Access Compliance Report

Public Rights-of-Way (Curb Ramps)

Intersection ID: 52927	Main Street: EMORY_OAK_DR	Cross Street: GRAY_OAK_LN	Location: S
ADA ID: F8061266EC5E	Ramp Type: Perp	Initial Pass/Fail: Fail	Overall Compliance: No
		Severity Score: 8.75

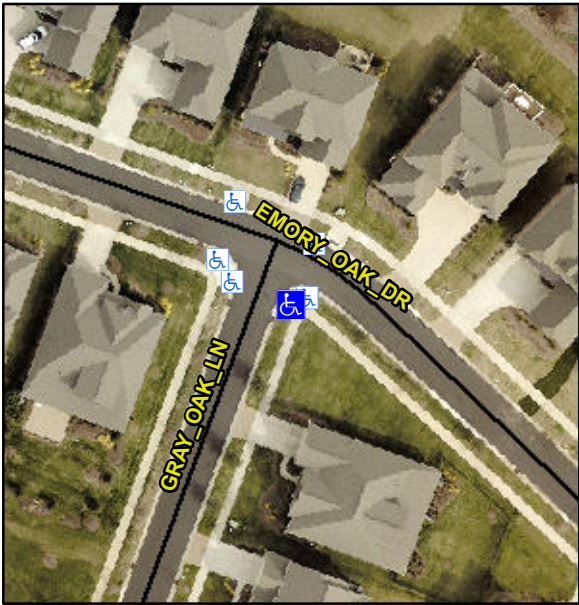
Codes/Mitigation Info/Possible Solution			Field Measurements/Component Compliance					
	Possible Solutions:		Compliance	Description	Data	Compliance	Description	Data
	Remove & Replace Entire Ramp.		N/A	Ramp Length (in)	100.0	Yes	Ramp Slope (%)	7.3
			No	Ramp Width (in)	46.0	Yes	Ramp XSlope (%)	1.4
			N/A	Flare Type LT	N/A	N/A	Flare Type RT	N/A
			N/A	Flare Slope LT (%)	N/A	N/A	Flare Slope RT (%)	N/A
			N/A	Flare Traversable LT?	N/A	N/A	Flare Traversable RT?	N/A
			N/A	Landing Length (in)	N/A	N/A	DWS Provided?	N/A
			N/A	Landing Width (in)	N/A	N/A	DWS Contrast?	N/A
			N/A	Landing Slope (%)	N/A	N/A	DWS Length (in)	N/A
			N/A	Landing X Slope (%)	N/A	N/A	DWS Full Width?	N/A
Surveyor Notes:	N/A		N/A	Landing Curb? (Y/N)	N/A	N/A	DWS Offset (in)	N/A
			N/A	Shared Landing?	N/A			
			N/A	Gutter Ponding?	N/A	N/A	Gutter Slope (%)	N/A
			N/A	Gutter Lip Ht (in)	N/A	N/A	Gutter X Slope (%)	N/A
			N/A	Painted X Walk1?	No	N/A	Painted X Walk2?	N/A

X Walk 1 Direction	To NW		X Walk 2 Direction	N/A
			N/A	X Walk 1 Width (in)	N/A	N/A	X Walk 2 Width (in)	N/A
				X Walk 1 Slope (%)	3.6		X Walk 2 Slope (%)	N/A
				X Walk 1 X Slope (%)	3.2		X Walk 2 X Slope (%)	N/A
			N/A	Ramp inside XWalk1?	N/A	N/A	Ramp inside XWalk2?	N/A
PROW/ADA:	Not Found, R304.5.1			Road Slope (%)	N/A	N/A	Clear Space?	N/A
				Road X Slope (%)	N/A	N/A	Clear Space to XWalk (in)	N/A
			N/A	Any Obstructions?	N/A	N/A	Storm Grate/Utility Hazard?	N/A
				Obstruction Type			Storm Grate/Utility Type	
					N/A			N/A
						Yes	Surface Condition? (G/P)	Good
Total Cost:		\$ 1850.00
